Re: Oak Woods Subdivision  
Town of Chester – SBL: 15-1-27.41

In reference to the above project, attached please find one (1) copy of the revised Subdivision Plan Set, one (1) copy of the Drainage Analysis Report, and one copy of the AG-Data Statement. The plans have been revised in accordance with the comment letter dated November 23, 2021. The responses coincide with your comment letter are as follows:

## Existing 24in. C.M.P.

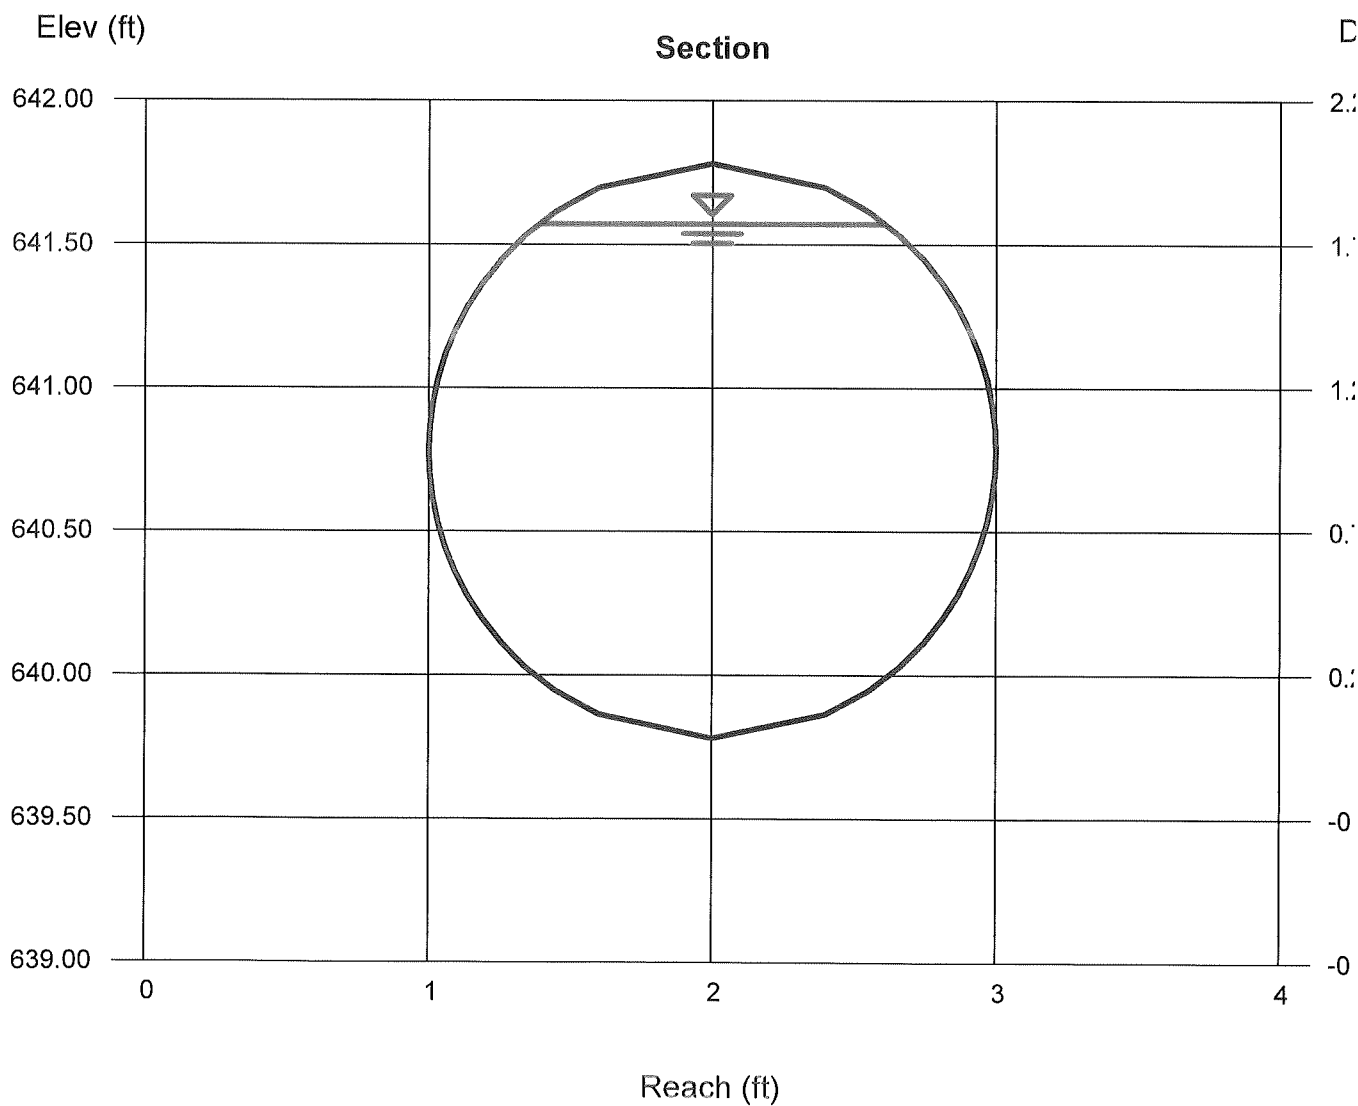
5. SHPO letter has been submitted to the town before the previous meeting.
6. Lot 6 driveway now shows slope stabilization blanket areas.
7. Culvert sizes, inverts and slopes are now provided on the plan. The pipe sizing calculation has been included as an attachment with this response letter.
